**BEFORE THE PUBLIC UTILITIES COMMISSION OF THE
STATE OF CALIFORNIA**

Rulemaking 16-02-007
(Filed February 11, 2016)

**COMMENTS OF THE CALIFORNIA INDEPENDENT SYSTEM OPERATOR
CORPORATION ON ADMINISTRATIVE LAW JUDGE'S RULING SEEKING
COMMENT ON PROPOSED SYSTEM REFERENCE PLAN AND RELATED
COMMISSION POLICY ACTIONS**

Western Planning Regions

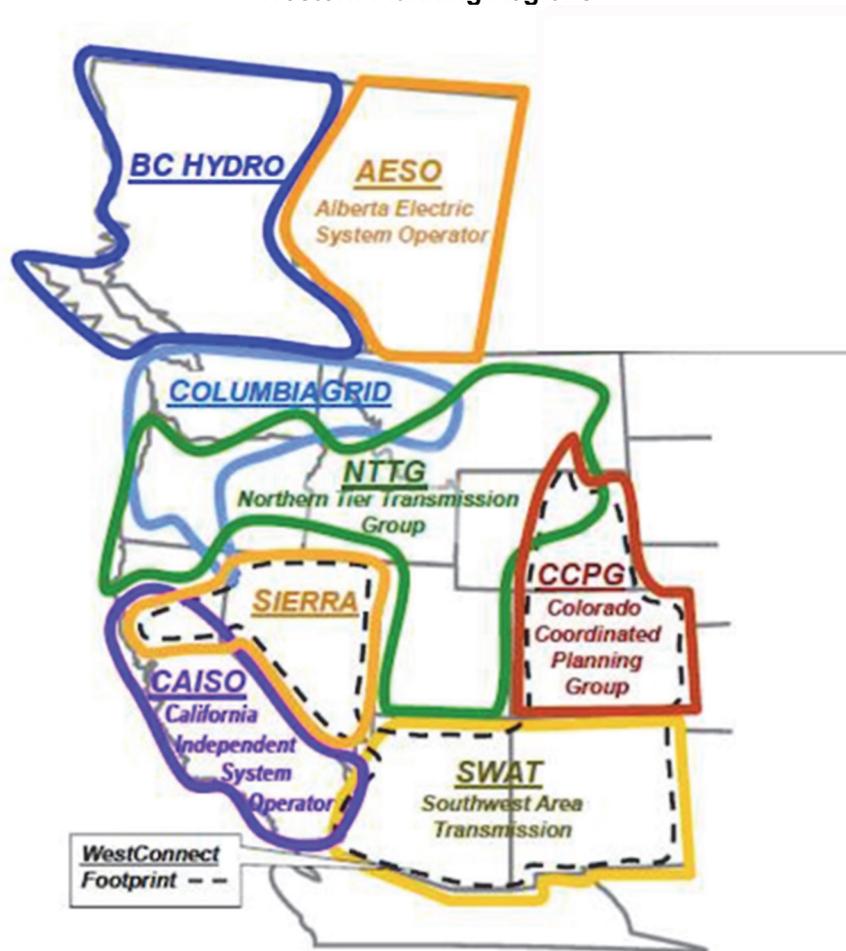
In 2011, FERC issued Order 1000, which required a robust, open, and transparent regional planning and interregional coordination process that identifies more efficient or cost-effective regional/interregional transmission and non-transmission solutions and provides a mechanism for regional/interregional cost allocation. In the Western Interconnection, there are six main planning regions as shown in the map below. CAISO actively participates and advances interregional coordination with the three other U.S. western planning regions: ColumbiaGrid, Northern Tier Transmission Group, and WestConnect. The western planning regions interregional coordination cycle spans two years and starts in each even-numbered year.¹⁹

Entities within overlapping planning boundaries only participate in one of the planning regions.
